NOTICE OF ADDENDUM  
ADDENDUM NO. 2  
CONTRACT NO. 8119

S. BRYAN STREET, DALEY DRIVE, JAMES STREET AND THORP STREET  
RECONSTRUCTION DISTRICT – 2018

**Addendum #1 referenced several plan sheets that were not attached to the addendum. See attached for the revised plan sheets.**

ELECTRICAL DETAILS 3

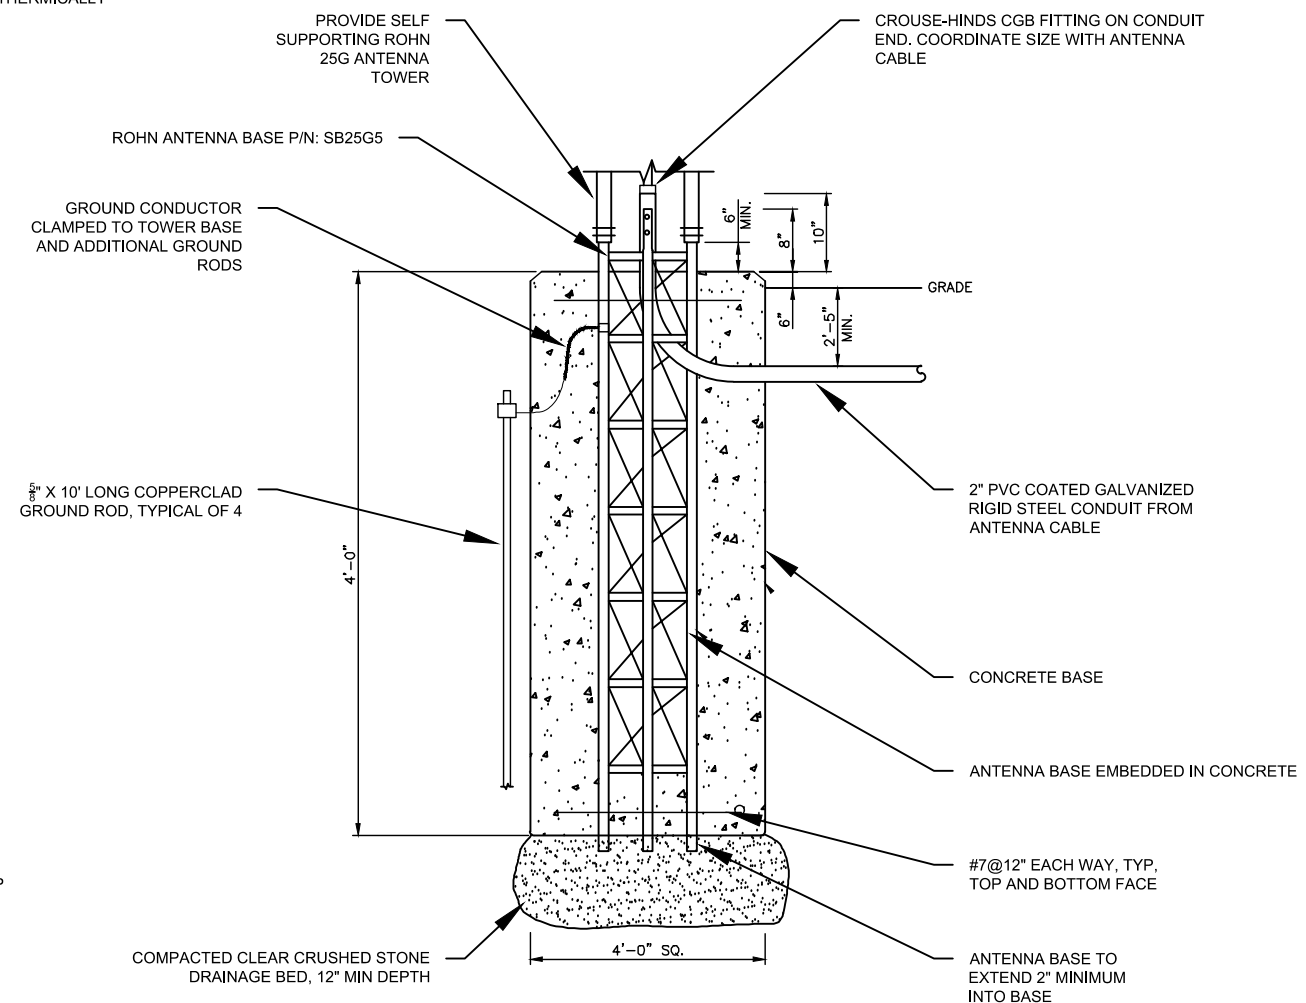
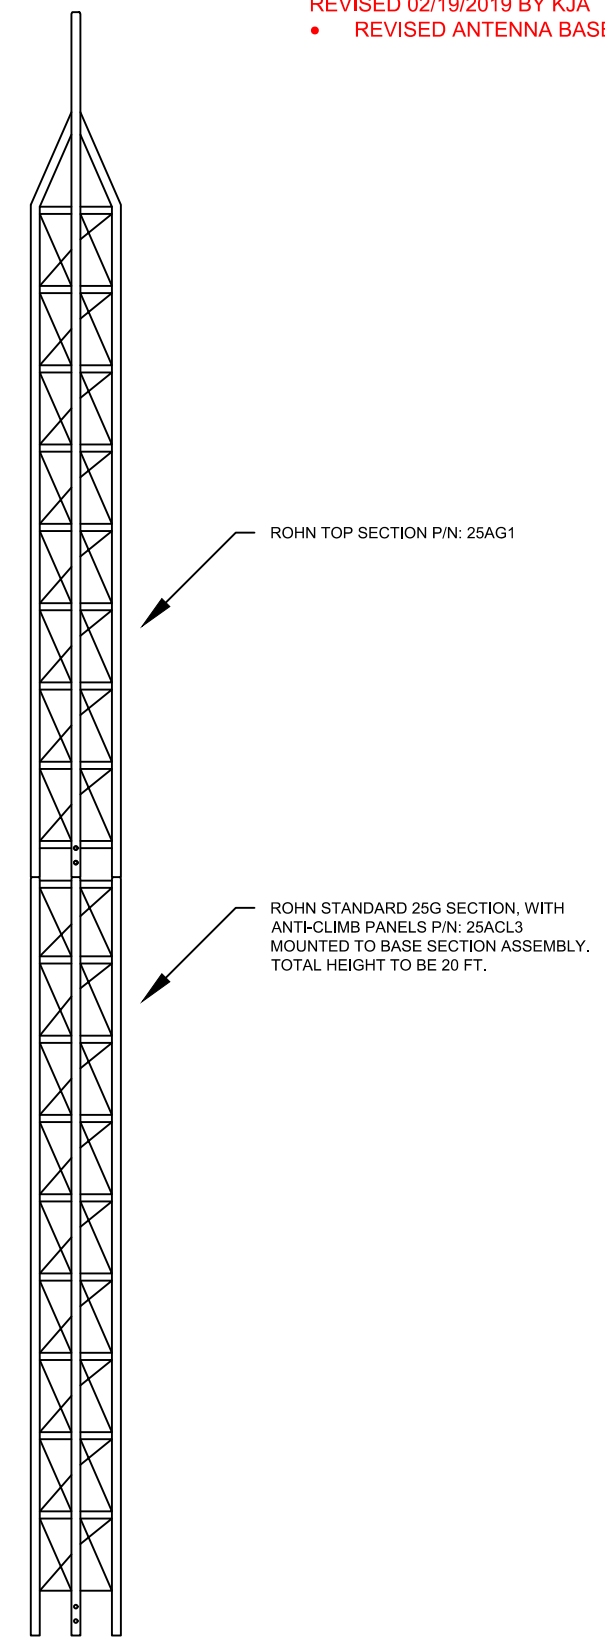
REVISED 02/19/2019 BY KJA  
 • REVISED ANTENNA BASE.
